**REMOVAL ACTION REPORT FOR CONTAMINATED SEDIMENT ASSOCIATED WITH THE SURFACE WATER OPERABLE UNIT (ON-SITE) AT THE PADUCAH GASEOUS DIFFUSION PLANT, PADUCAH, KENTUCKY (DOE/LX/07-0357&D2)**

**REMOVAL ACTION REPORT FOR CONTAMINATED SEDIMENT  
ASSOCIATED WITH THE SURFACE WATER OPERABLE UNIT  
(ON-SITE) AT THE PADUCAH GASEOUS DIFFUSION PLANT,  
PADUCAH, KENTUCKY**

Figure A.4. Outfall 001 Actual Excavation Limits

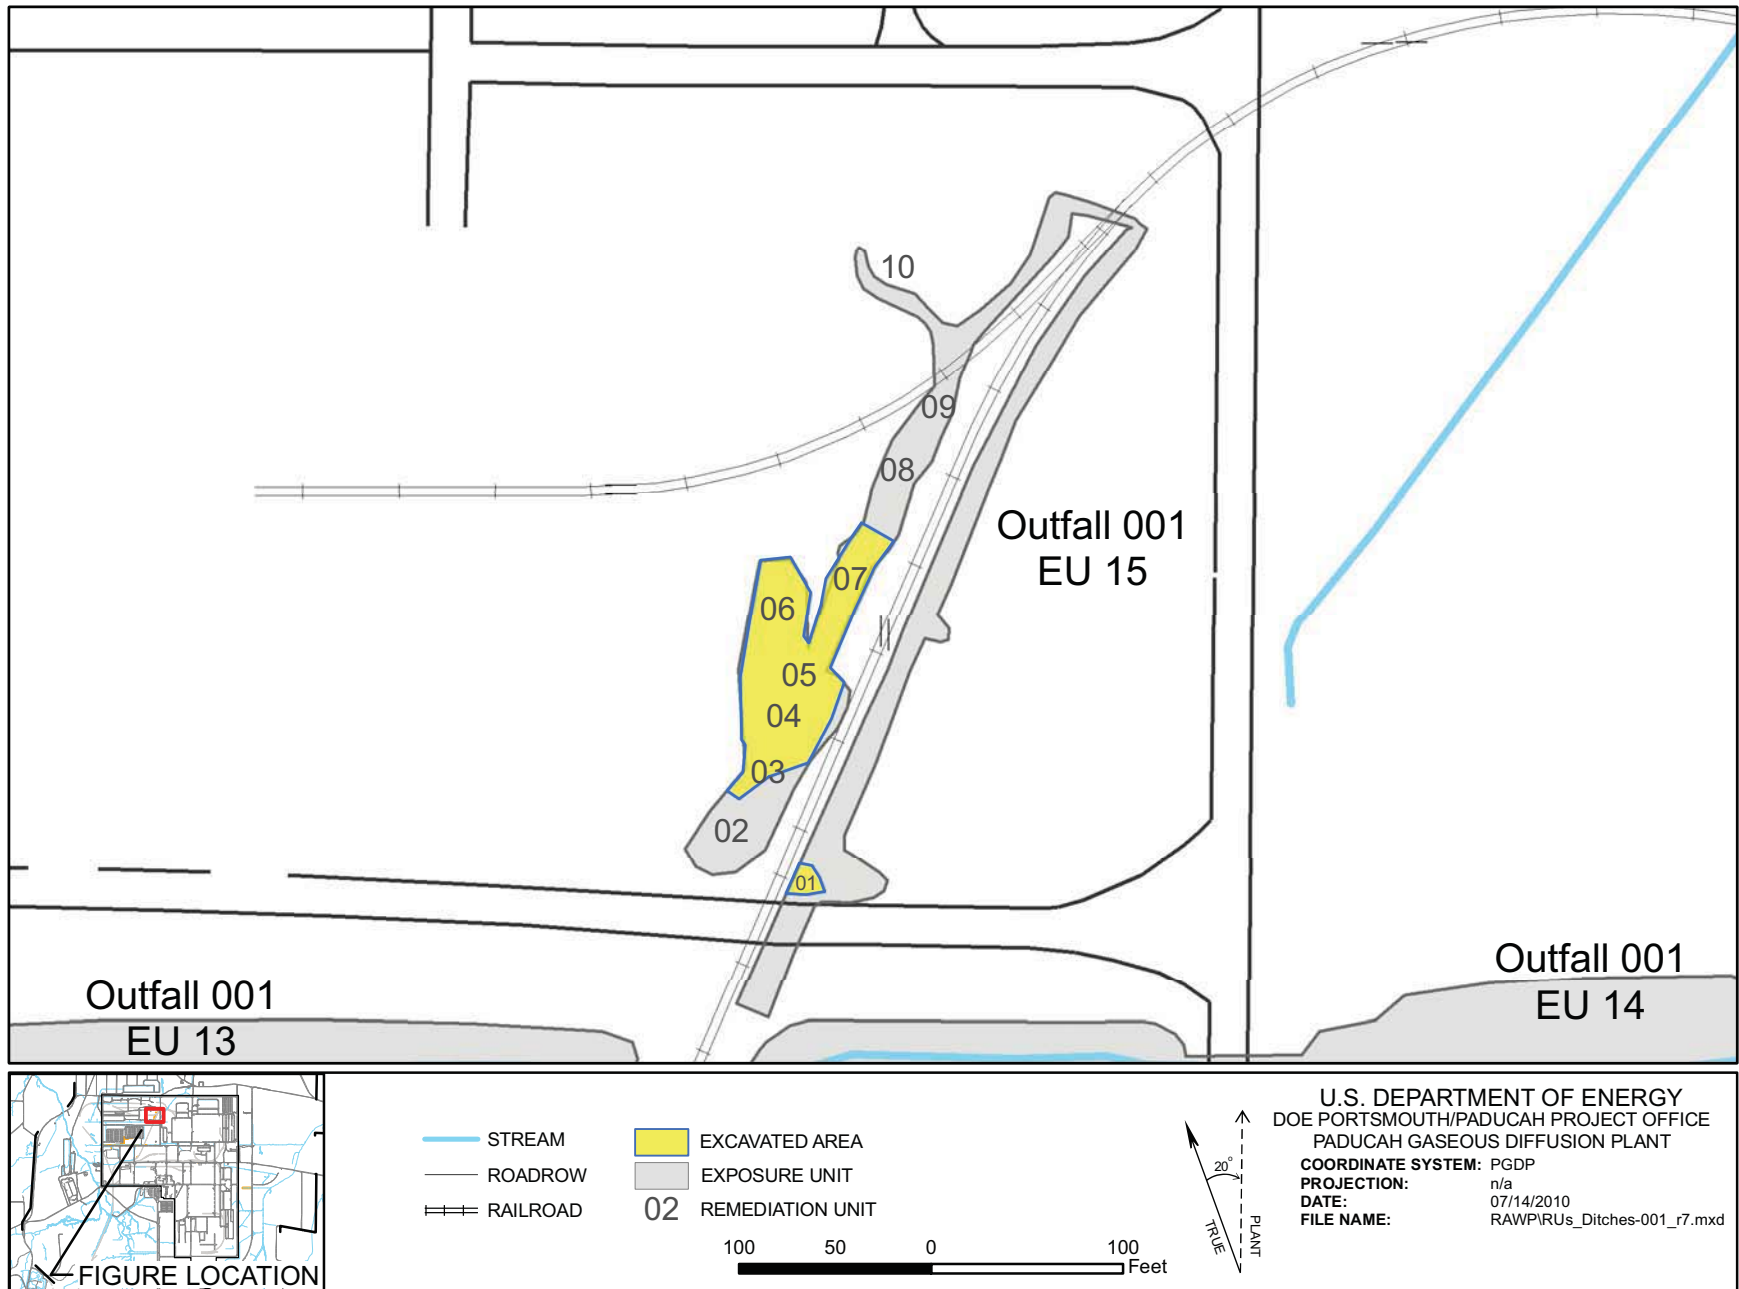
**Comment 3:** Summaries of Results, Outfall 001, Page 3, 4th Paragraph, 1st & 2nd Sentences: Please state which RUs were excavated to what depth below grade. This information could also be added visually (via shading, coloring or reference) in Figure A.4.

“At the five RUs addressed under this action, one RU, RU 6, was excavated to 2 ft. The remaining RUs were excavated to 3 ft at some SUs and 4 ft at other SUs (see Figure A.4).”

Figure A.9. NSDD Section 3 EUs 01 & 02 Actual Excavation Limits

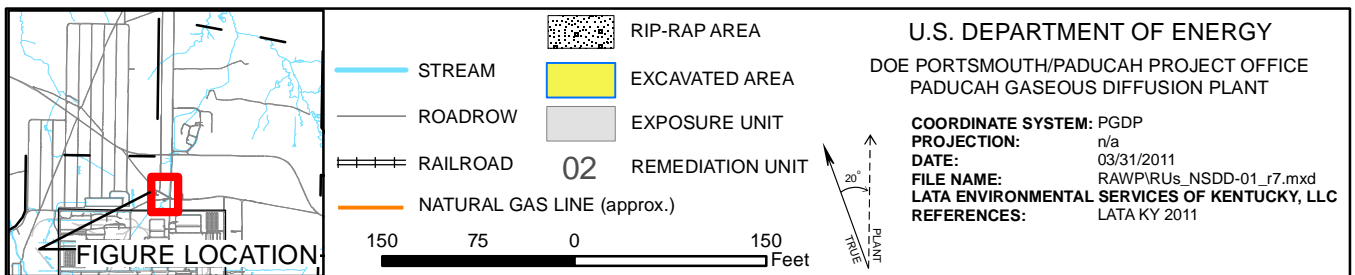
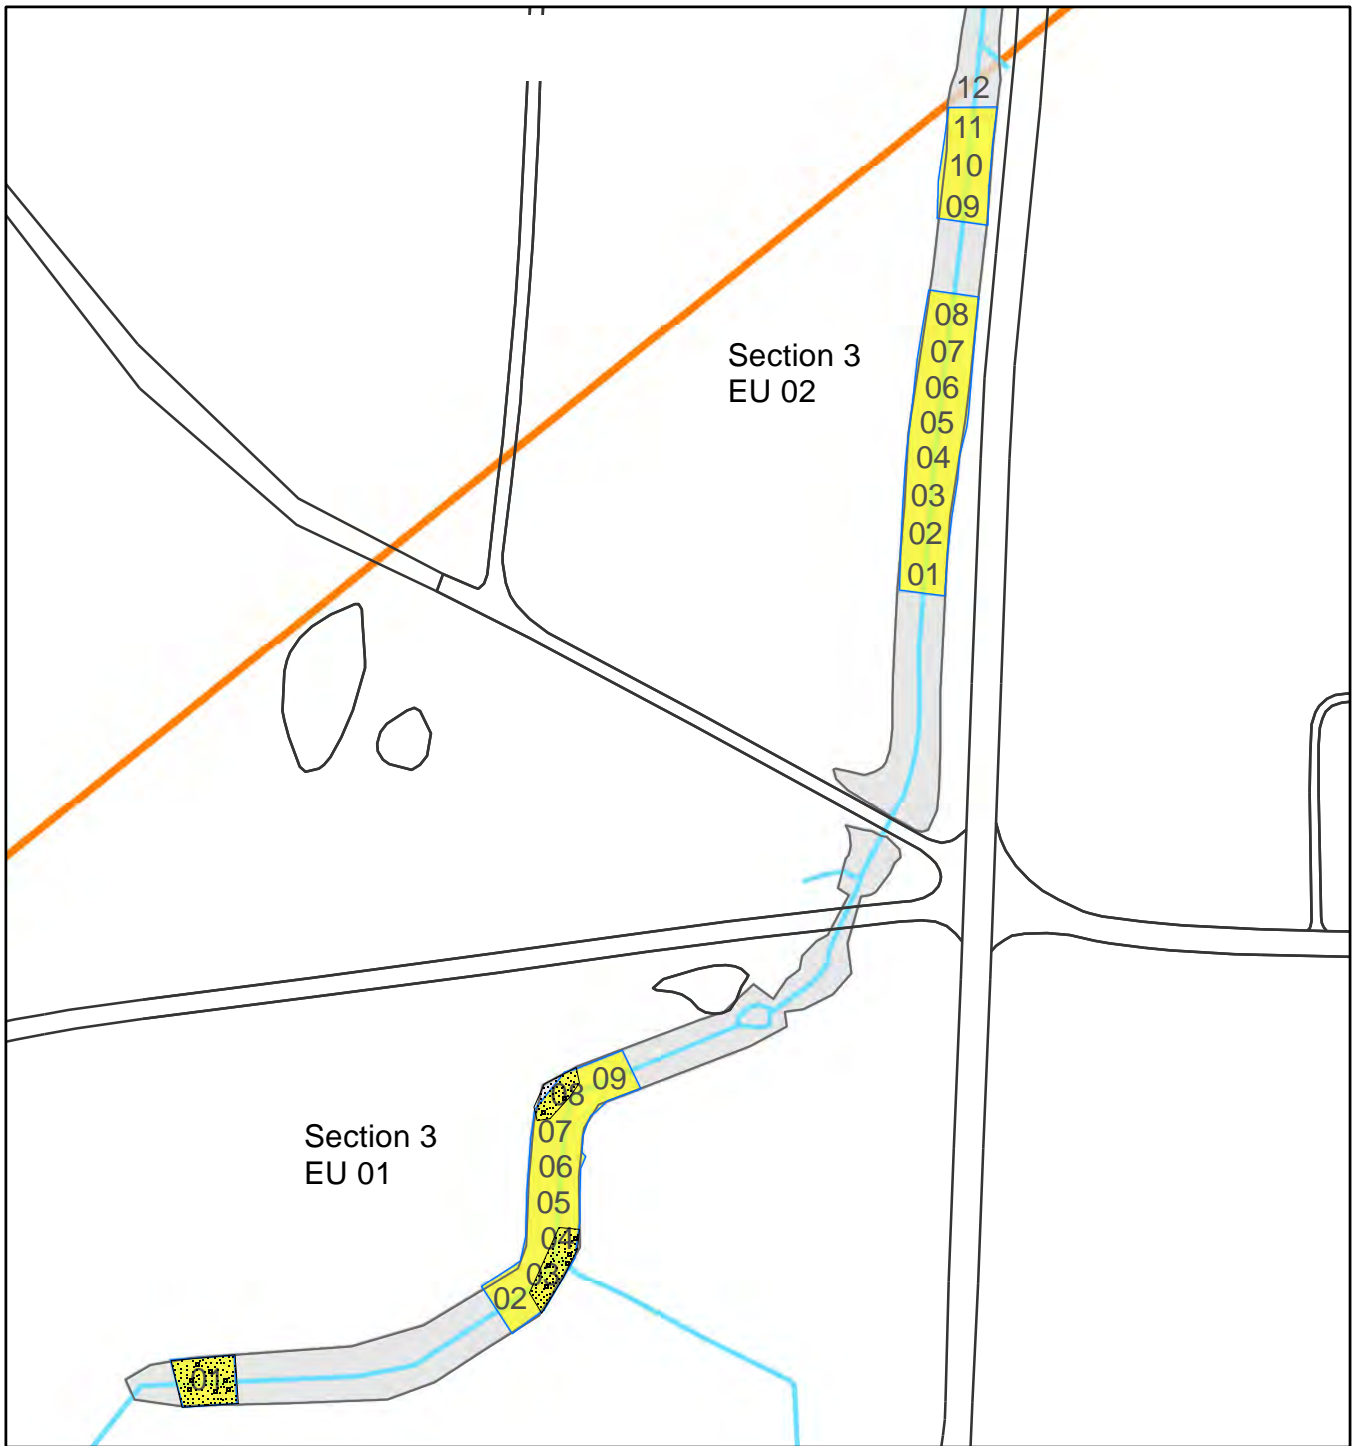
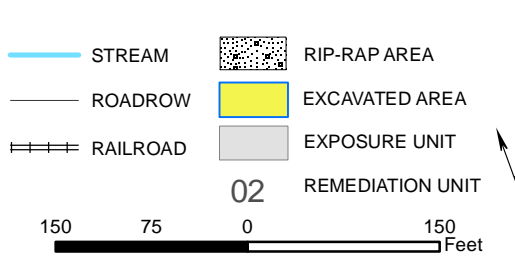
**Comment 12:** Summaries of Results, NSDD Sections 3 and 5, Page 5, 1st Paragraph, 4th Sentence: Please add the location of the high pressure gas line on Figures A.9 and C1-13. Please state the approximate square footage that was not addressed and provide an explanation of how not performing a removal action at a slated-for-excavation RU would affect the Residual Risk Evaluation for this EU.

**Response 12:** The verification sample for RU 12 was removed from Figure C1.11. The square footage not excavated (approximately 1,225 ft<sup>2</sup>) also was added to the report, and text was added explaining why not excavating the identified area did not affect achievement of the project's RAO. The explanation included is as follows, ”Sampling results collected previously from areas not excavated and collected from areas excavated were used in the risk evaluation for this EU. The residual risk for this EU was below the cumulative risk goal; therefore, the inability to excavate the area around the gas line did not affect the attainment of the project's RAO.”
